Groundwater Remedy Construction, PG&E Topock Compressor Station, Needles, California

Work Variance Request #10 – Revised Alignment for Pipelines C18 (East Ravine) and I1 (Bat Cave Wash), and Consolidation of Pipes/Conduits in the Southernmost Area of TCS

Date Submitted: 12/1/21

Variance Request No.: 10

WORK VARIANCE REQUEST #10 - PROPOSED CONSOLIDATION OF PIPES/CONDUITS IN L1/L2/D SOUTH OF FUTURE BUILDING INTO A CENTRAL UTILITY CORRIDOR AND REALIGNMENT OF L3 TO CONNECT WITH K

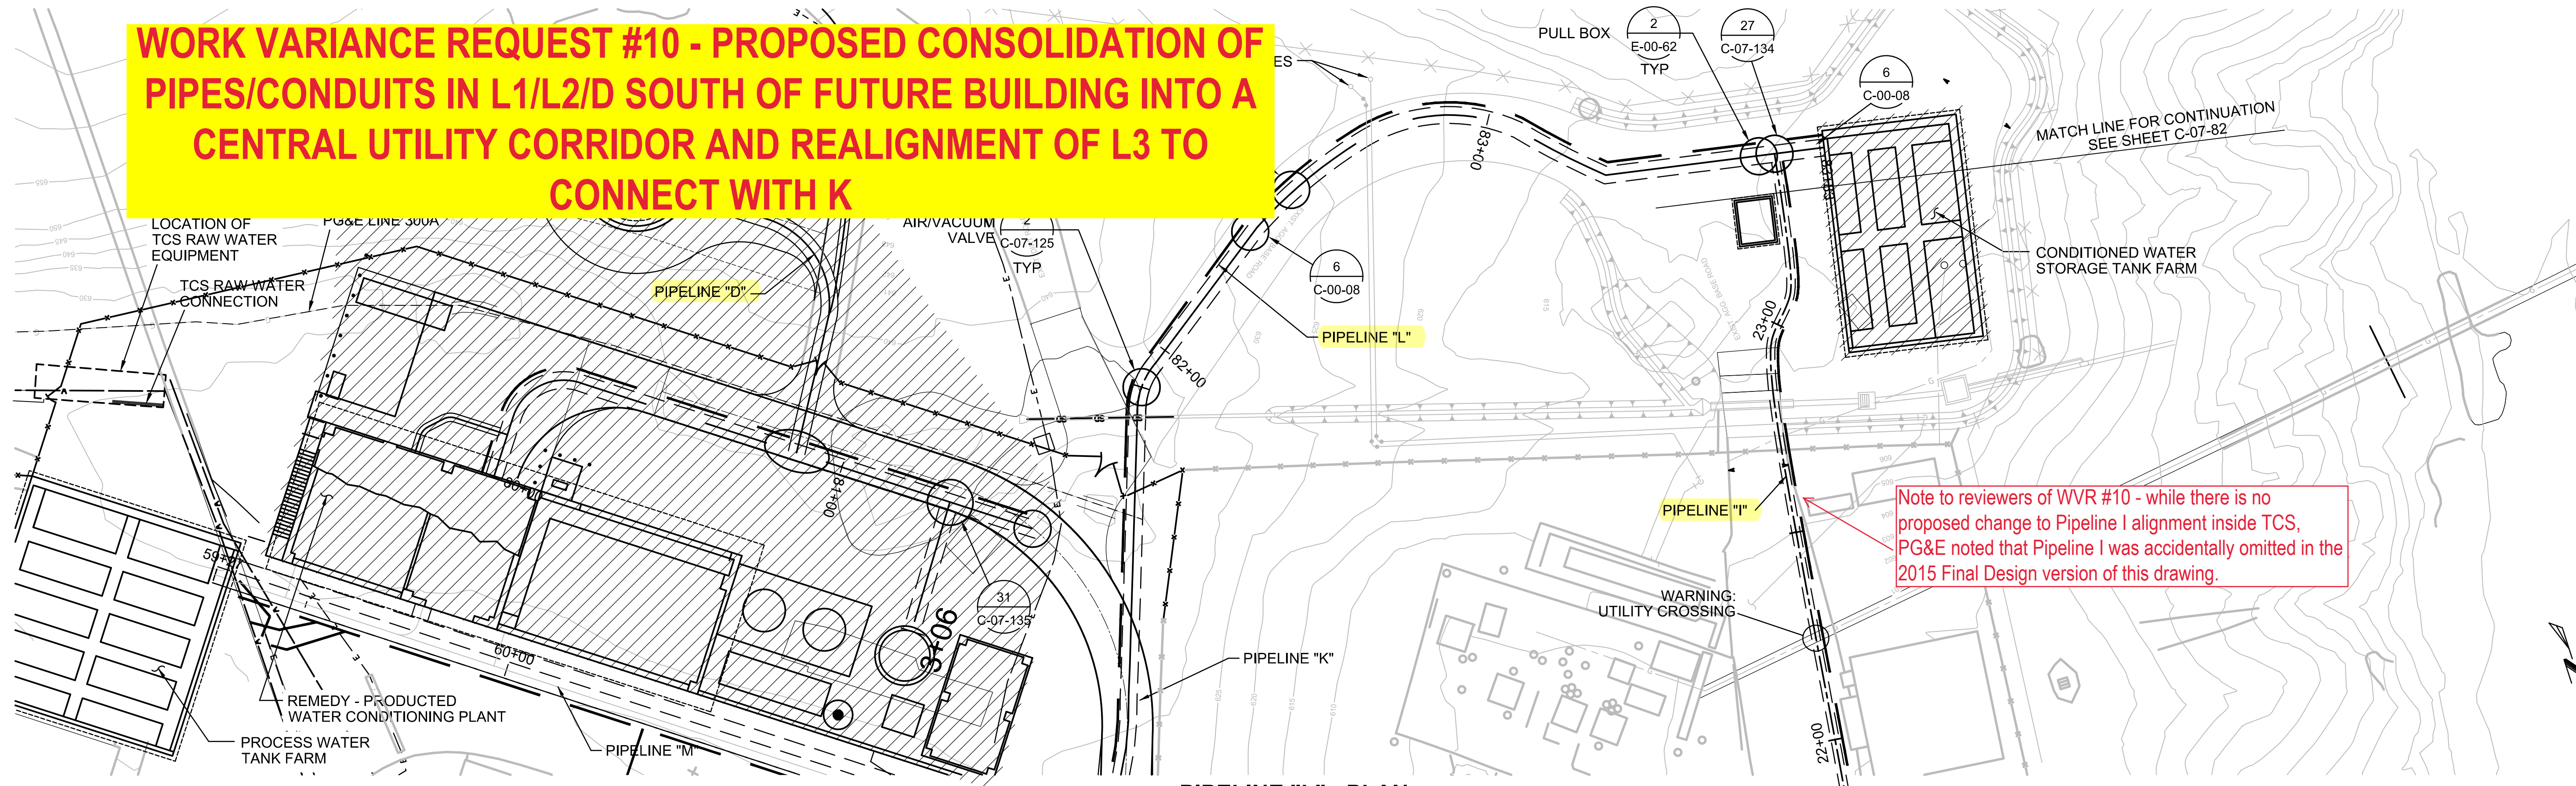
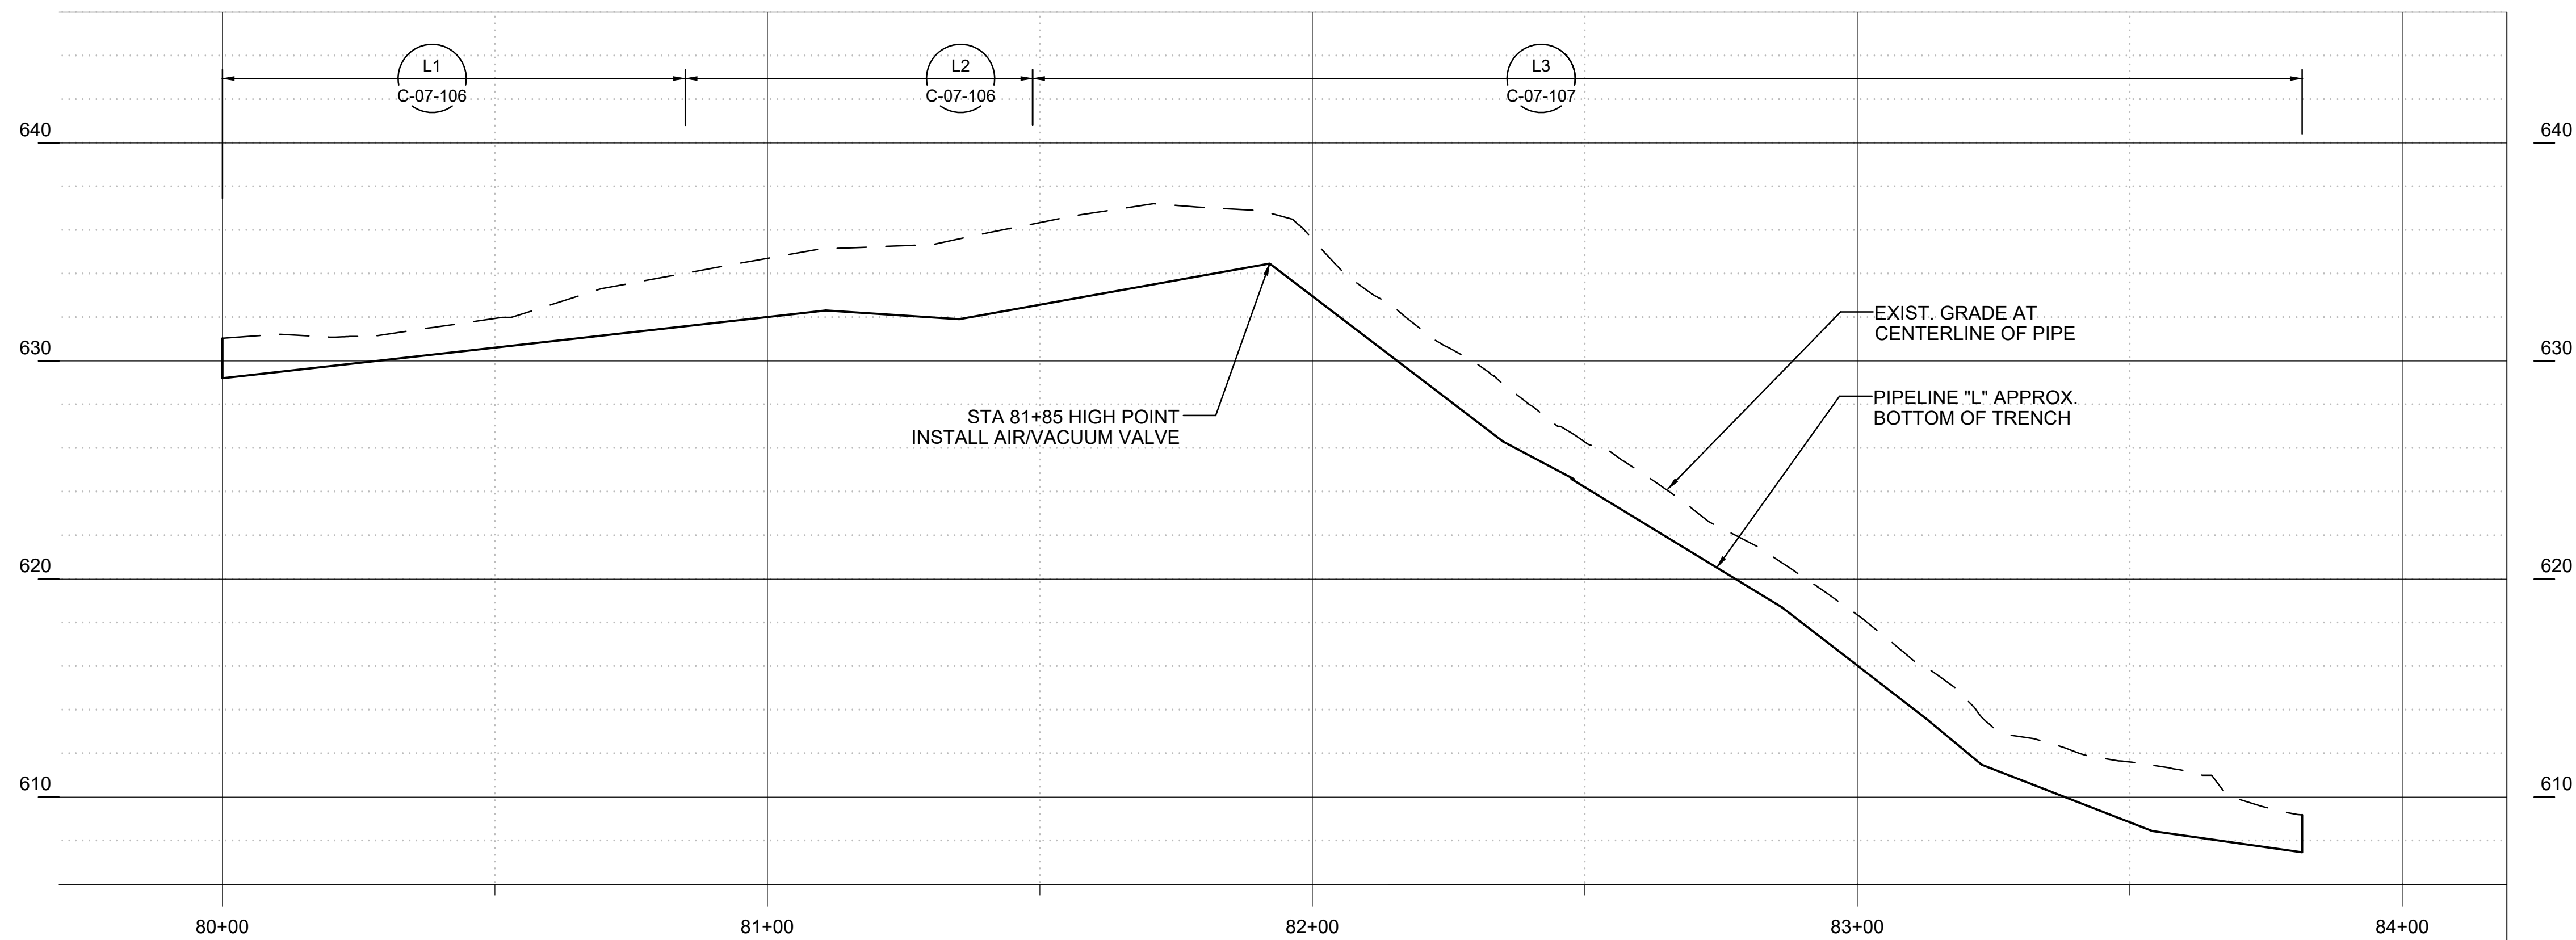
Consolidation of pipes/conduits in southernmost area of TCS into a central utility corridor – The two main revisions are 1) move all pipes/conduits from Pipelines D1, D2, L1, and L2 that are located south of the future remedy-produced water conditioning plant to the expanded M1 and M2 trenches, and 2) realign Pipeline L3 to connect with Pipeline K. Essentially, this move consolidates remedy piping/conduits in the southernmost area of TCS into a central utility corridor for a safer/easier construction (further away from PG&E's 300A gas pipeline and out of the rocky area) as well as ease of future maintenance (inside a common trench and utility corridor).

7. Soil disturbance: an increase of 6 cubic yards.
8. Linear footage of liquid conveyance piping/conduits: 0 feet.
9. Linear footage of trench: an increase of 48 feet.
